Rasp Mine

Zinc–Lead–Silver Project

Response to Submissions Report

Project Application No. 07_0018

Figure 2-2: Operation Scenario 4 (Project Increment) – Maximum Predicted 24 Hour Average PM_{10} Concentrations ($\mu g/m^3$) Criterion = $50\mu g/m^3$

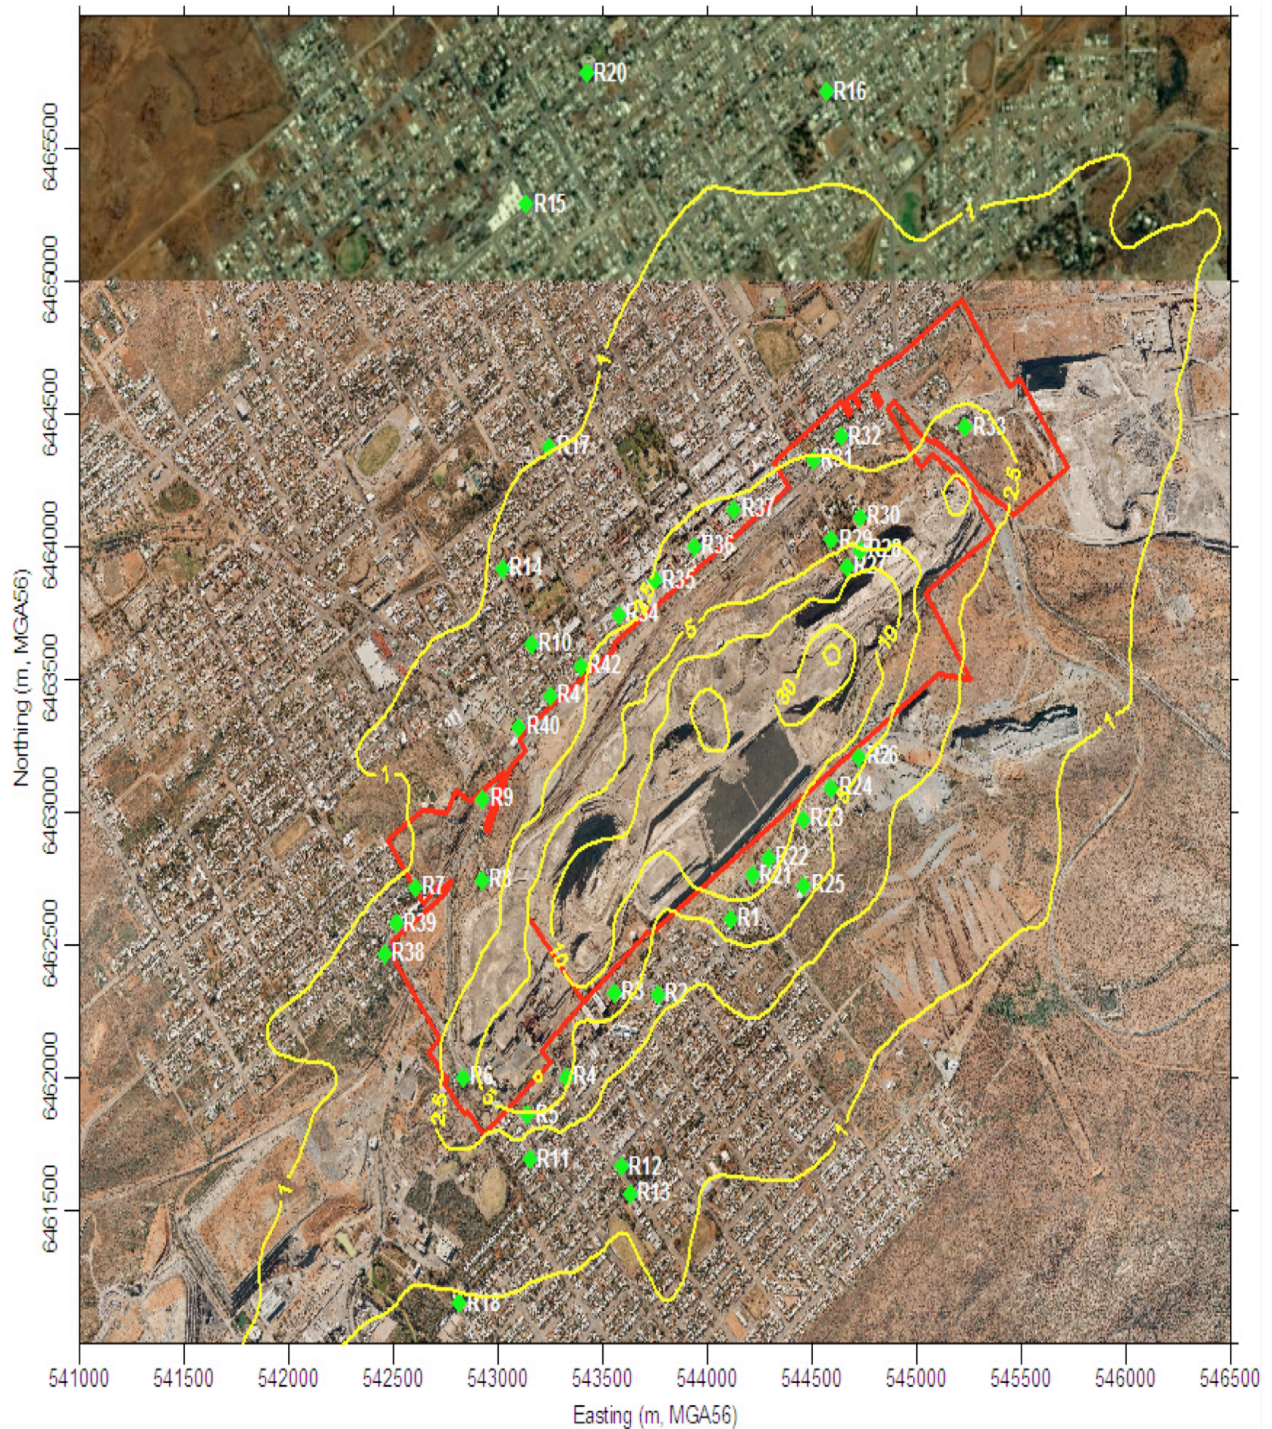
“At the meeting I agreed to provide further advice regarding the requirement of additional modelling assessment of the tailings storage facility. Based on the information provided, DECCW requests:

ENVIRON conducted the additional modelling on this basis. The modeling inputs and results are included in the *Air Quality Assessment Addendum* (ENVIRON, 2010) attached to the PPR, and are shown spatially as contours on **Figure 2-2**.

Modelling indicates that only those receptors in close proximity to the TSF1, specifically R1 and R21-R24 along the southeast boundary, show a noticeable influence due to the variation between normal and upset operations of the TSF1.

Figure 2-3: Project-related “Free Areas”

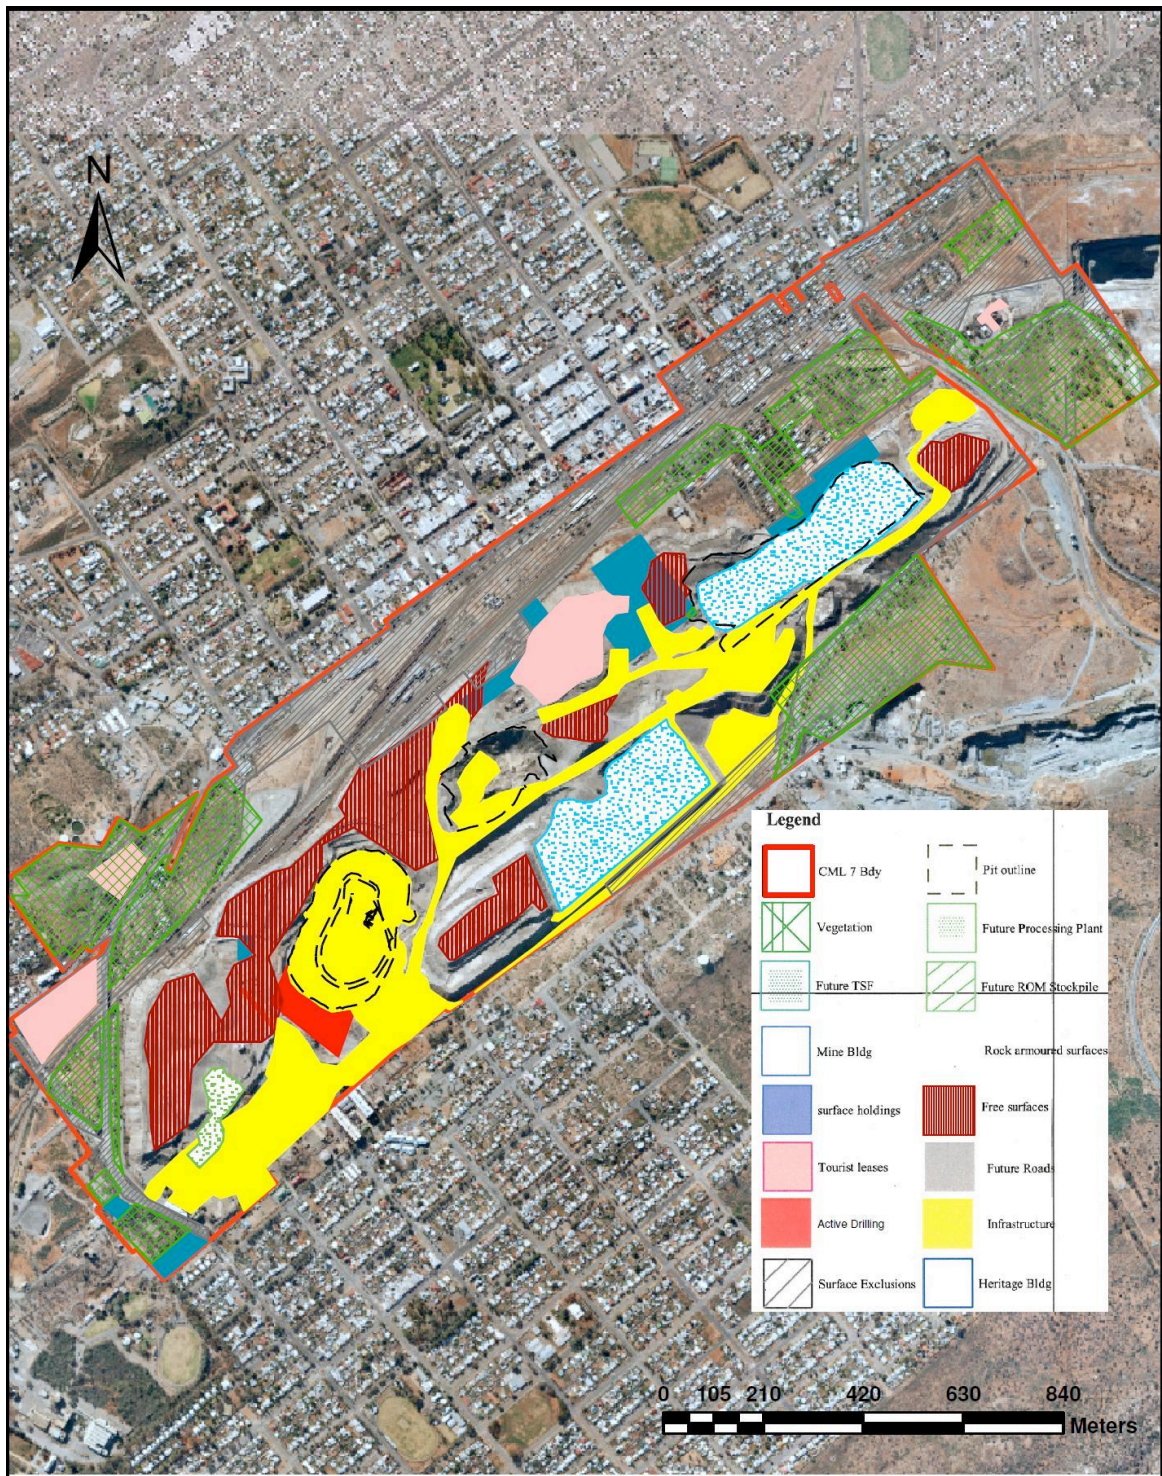
- **The commitment to “maintaining a surface crust to minimise potential wind erosion”. This should be revised to “chemical dust suppressants as per the manufacturer’s specifications, or more often as required, are to be used on all areas of the site potentially impacted by wind erosion”.**

The modelling undertaken as part of the *Air Quality Assessment Report* (ENVIRON, 2010) (Appendix H of EAR) was based on application of dust suppressants to all “free areas”. “Free areas” are defined as existing on-site areas which are exposed and which will not be impacted by the day-to-day operation of the mine. The location of all Project-related “free areas” are shown on **Figure 2-3**. To avoid confusion, BHOP proposes to add a reference to this figure in the SoC.

Chemical dust suppressants as per the manufacturer’s specifications, or more often as required, will be used on all areas of the site potentially impacted by wind erosion as per the ‘free areas’ marked on the following Figure.

Figure 2-5: Sweep paths for 26m B-double trucks entering / leaving the site

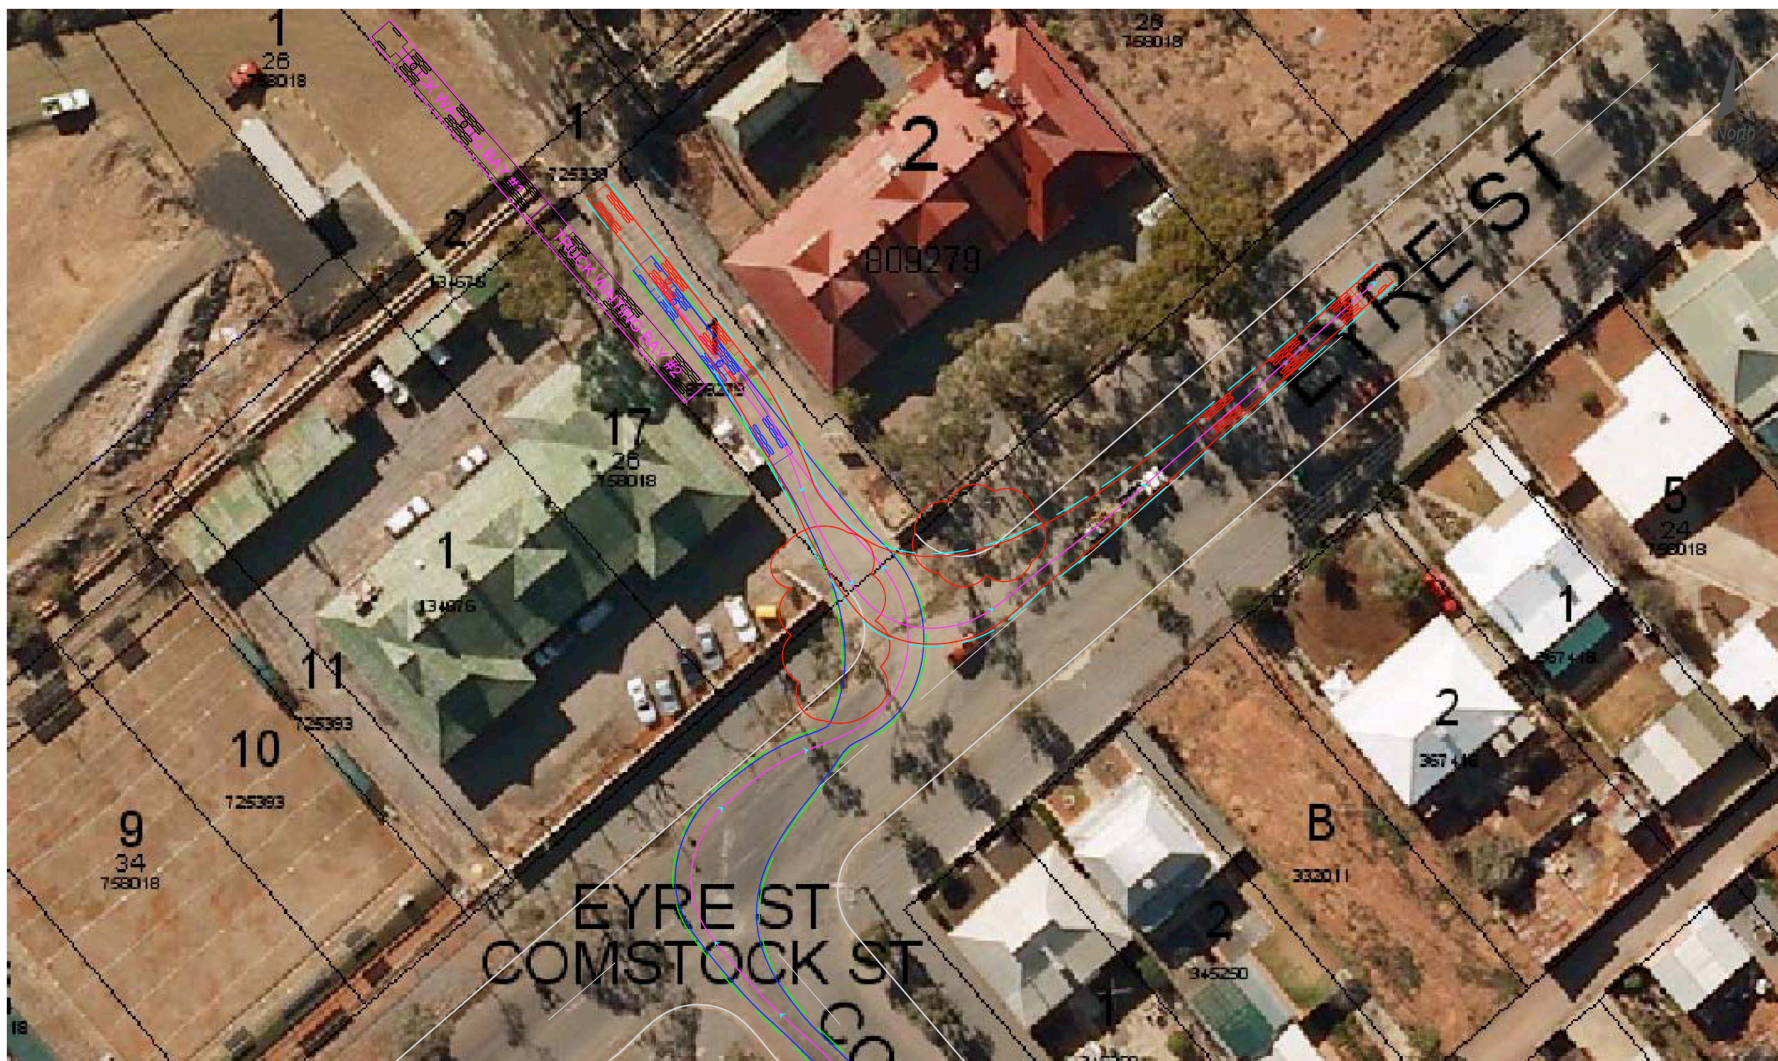
- The Eyre Street access modification should be in accordance with the recently approved DA264/2009. Turning paths are to be provided to demonstrate that the proposed haulage/delivery/construction vehicles will be able to turn left into or out of the Eyre Street access without crossing the centreline of Eyre Street.
- All work associated with access modification is to be completed prior to commencement of operations.

BHOP engaged Halcrow Pty Ltd to further assess the Eyre Street site access arrangements and any affects on the Comstock Street intersection. The results of this assessment are presented in **Figure 2-5** and **Figure 2-6**.

Figure 2-5 provides turning paths for 26 metre B-double trucks turning left into and out of the Eyre Street site access. The plan clearly demonstrates that these vehicles can enter and exit the site without crossing the centreline of Eyre Street. However, some minor modifications to the footpaths on both sides of the access will be required. BHOP will consult with BHCC and the RTA with regard to the detailed designs of the proposed footpath modifications. All modification works will be completed prior to the commencement of operations. A new commitment reflecting these requirements has been included in Section 3.
